Notice of Meeting
Polk City | Planning and Zoning Commission (P&Z)

May 20, 2019 | 6:00 pm
City Hall | Council Chambers

Date: May 14, 2019
 Project: Lakeside Fellowship Church

PRELIMINARY PLAT REVIEW

SITE PLAN AMENDMENT

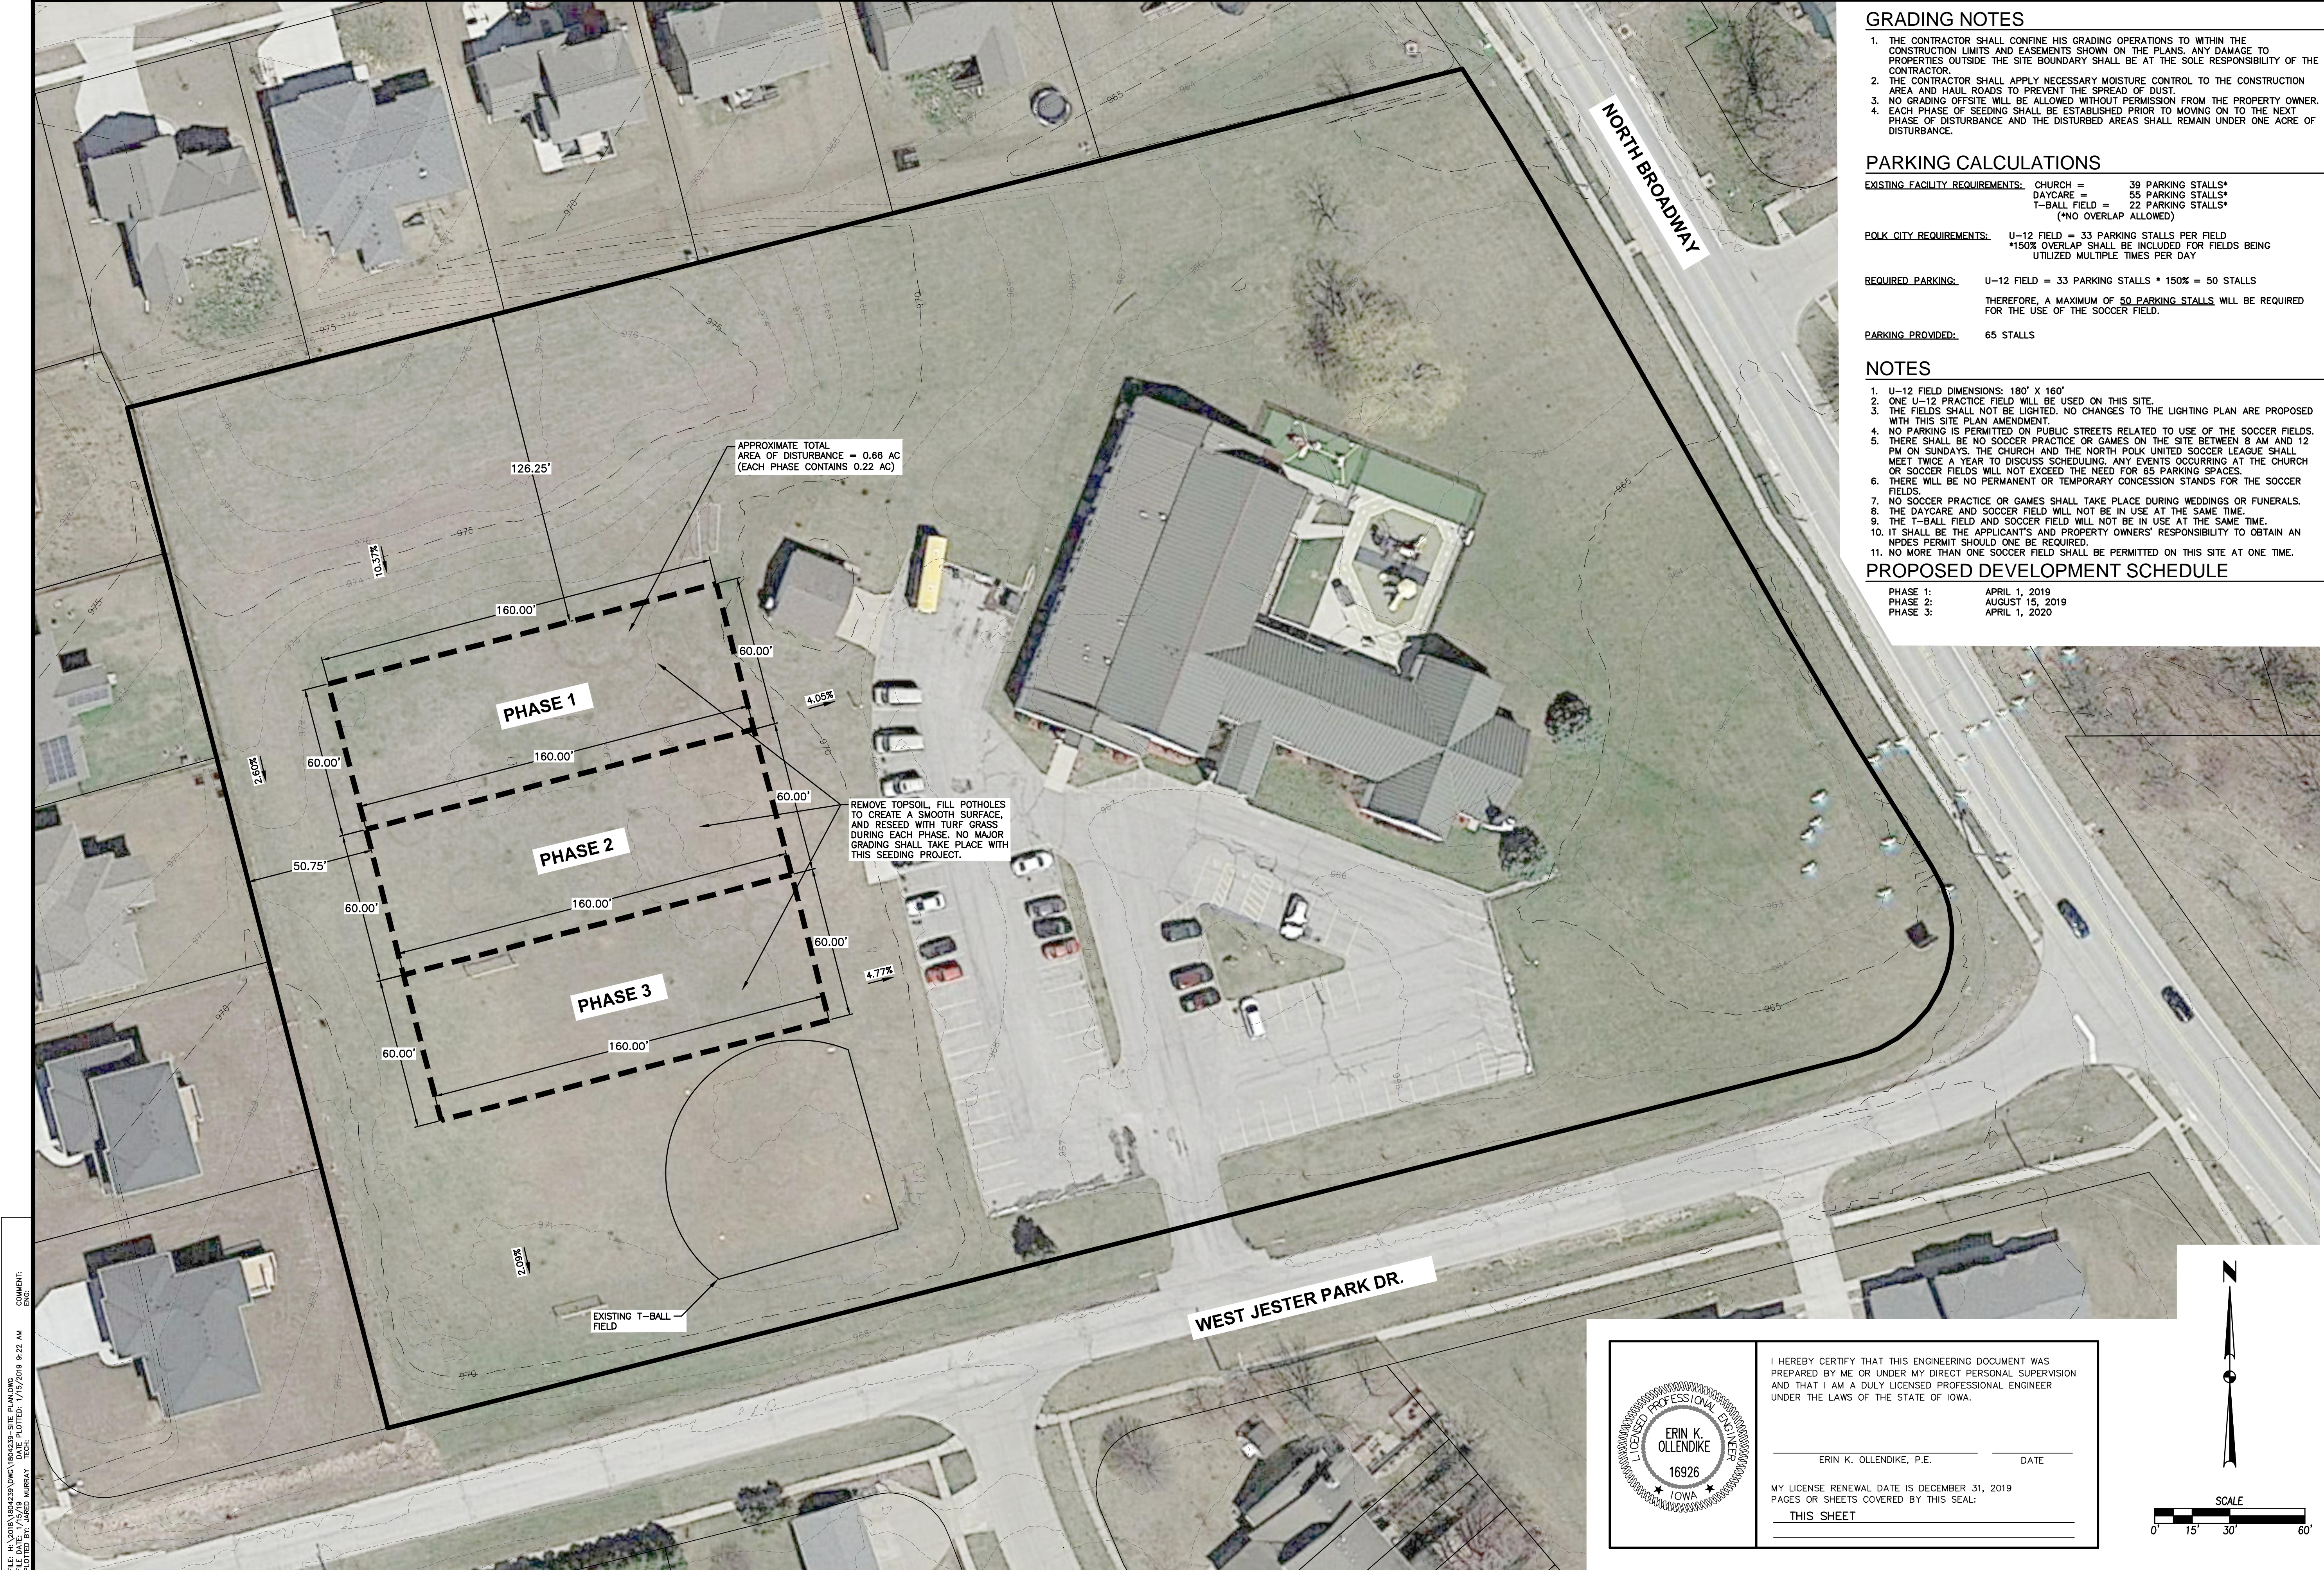
REVIEW COMMENTS: Pursuant to our review of Submittal #3, we offer the following comment:

1. Prior to this item being placed on the P&Z agenda, provide documentation that Beautiful Savior Lutheran Church, as owners of this property, has approved this site plan amendment.

Based on the foregoing, staff recommends approval of the Site Plan Amendment for Beautiful Savior Lutheran Church subject to the following:

1. P&Z comments, if any, are addressed prior to this item being placed on the Council agenda.
2. Payment of all fees to the City Clerk.

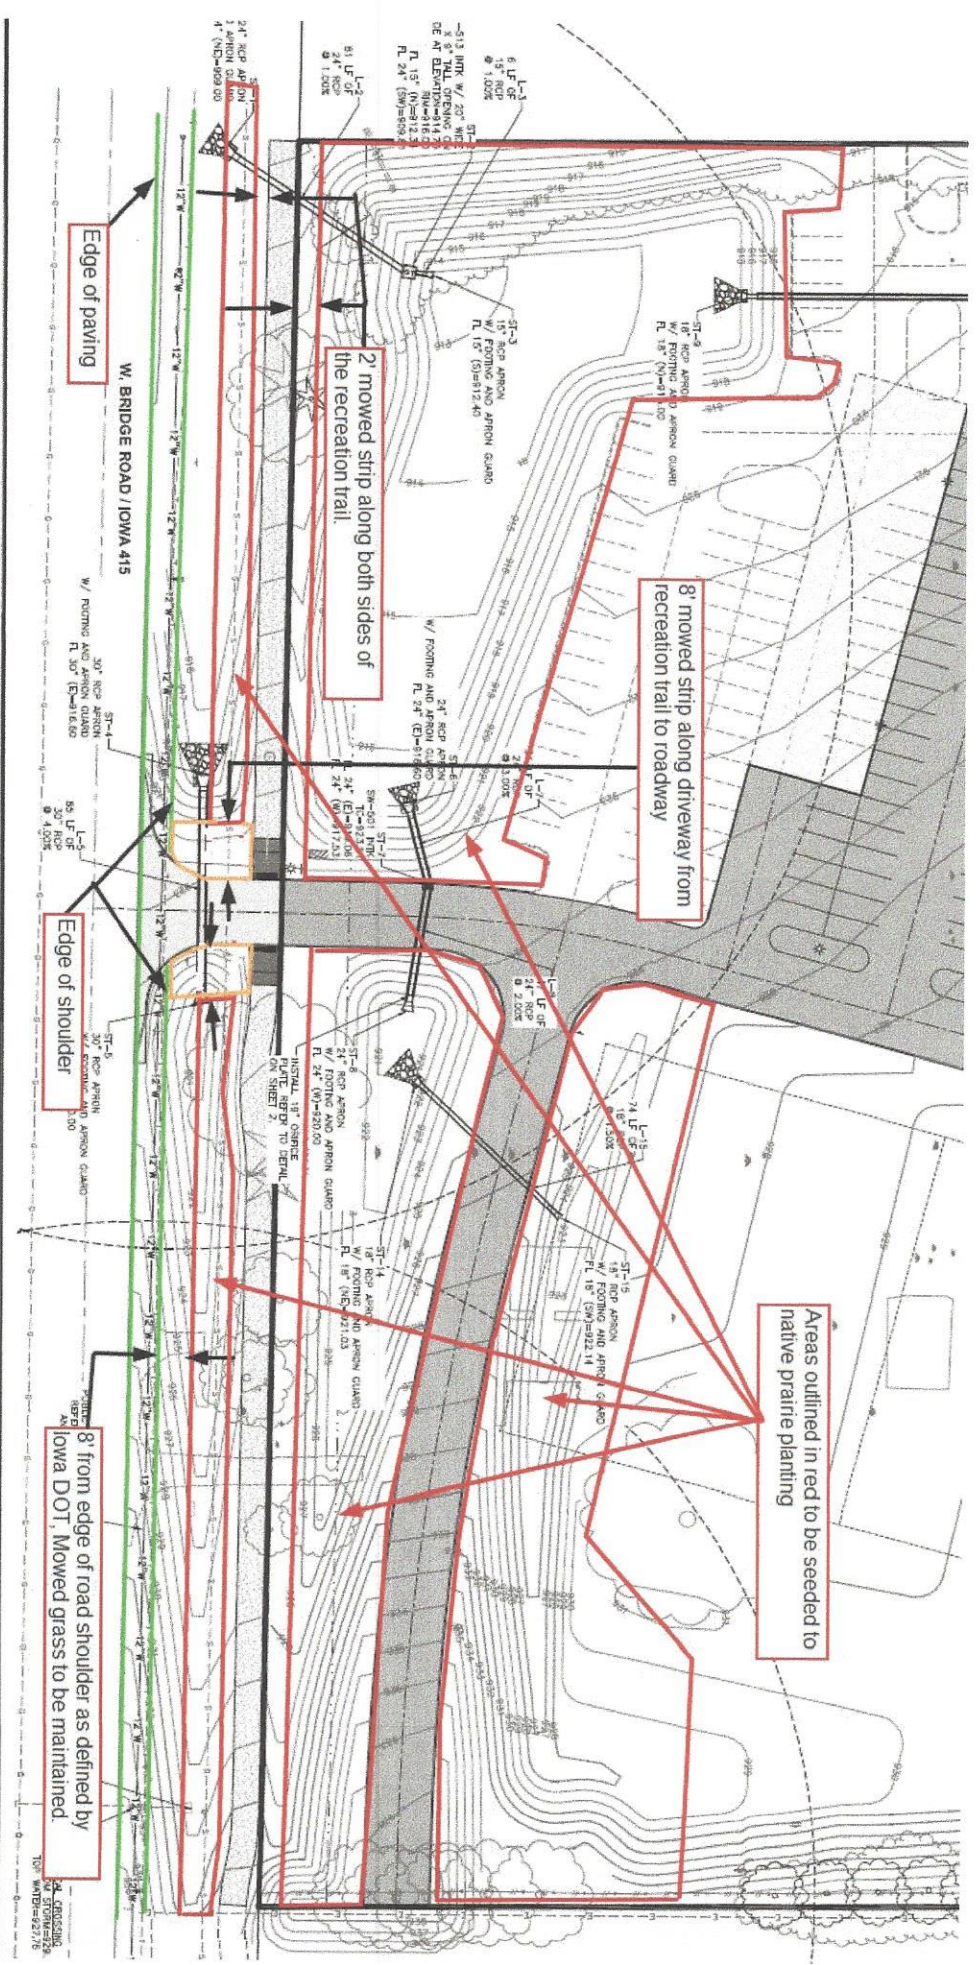
1. Since there are multiple seed mixtures for native plantings, please provide the proposed mixture(s) to be used for this site along with the height of the plants in each mixture. The seed mix used within the public right-of-way should include grasses and forbs up to maximum height of 3 feet. The seed mix(s) used on private property does not have a height limitation.

2. Prairie flowers can take up to three years to be fully established, so this area may not be very attractive until that point. However, if the prairie flowers are not established within three years, the City may wish to retain the right to require these areas to be reseeded with lawn mixture and mown as per usual.

Staff recommends approval of the Site Plan Amendment for Lakeside Fellowship Church subject to the following:

1. Each of the above review comments shall be addressed prior to this item being placed on the City Council agenda.
2. Payment of all fees to the City Clerk.
